# PREVOST

## WARRANTY BULLETIN

**WB14-55**

DATE :	DECEMBER 2014	SECTION :	16 - Suspension
EXPIRATION:	DECEMBER 2016		
SUBJECT :	SHOCK ABSORBER MOUNT NUTS ON IFS

Figure 1

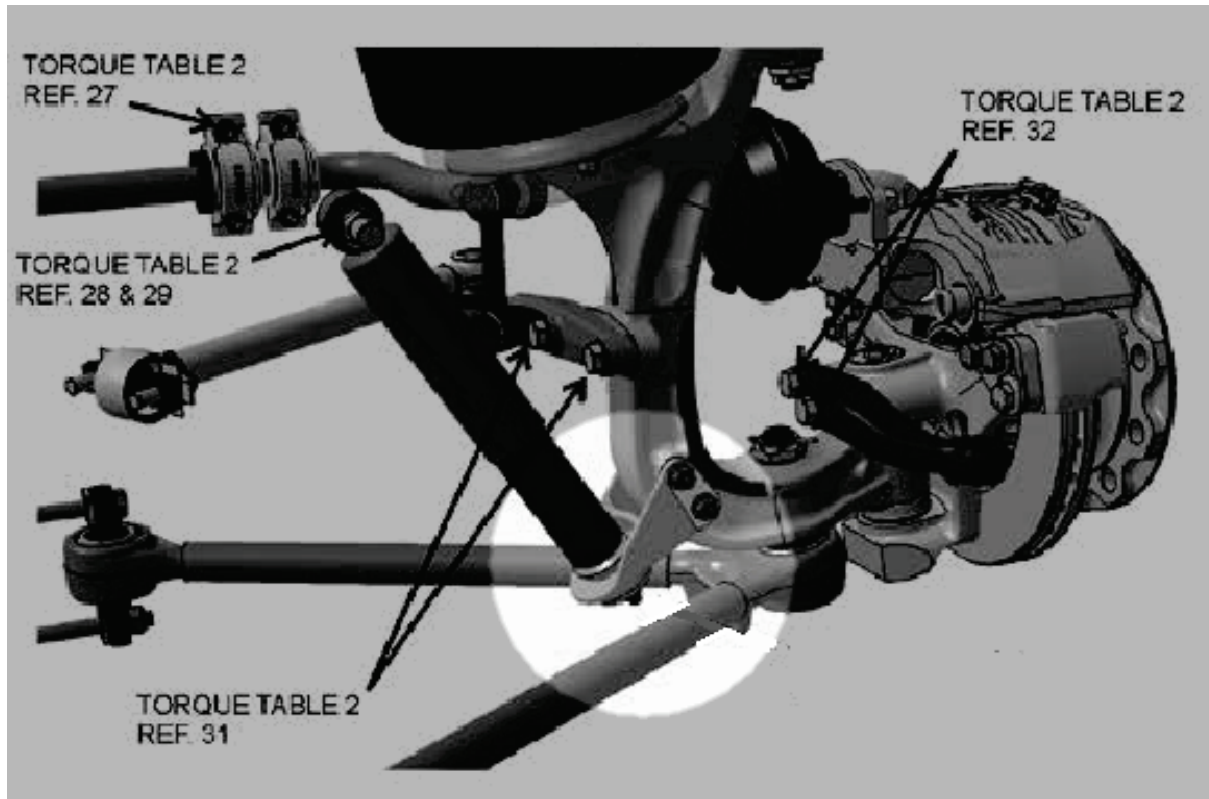
1. Inspect the nut head profile on the anchor bolts of the shock absorber mounting.(Fig.1)
2. Nut head profile must not show rounded corners. (Fig 2)
3. If round corners are found, replace bolt 5001790 and nut 5001771.
4. De-grease contact surfaces before re-assembly.
5. De-grease mounting bolt and let dry.
6. Tighten to 155 lbf-ft.
7. Apply Valvoline anti-corrosion agent.
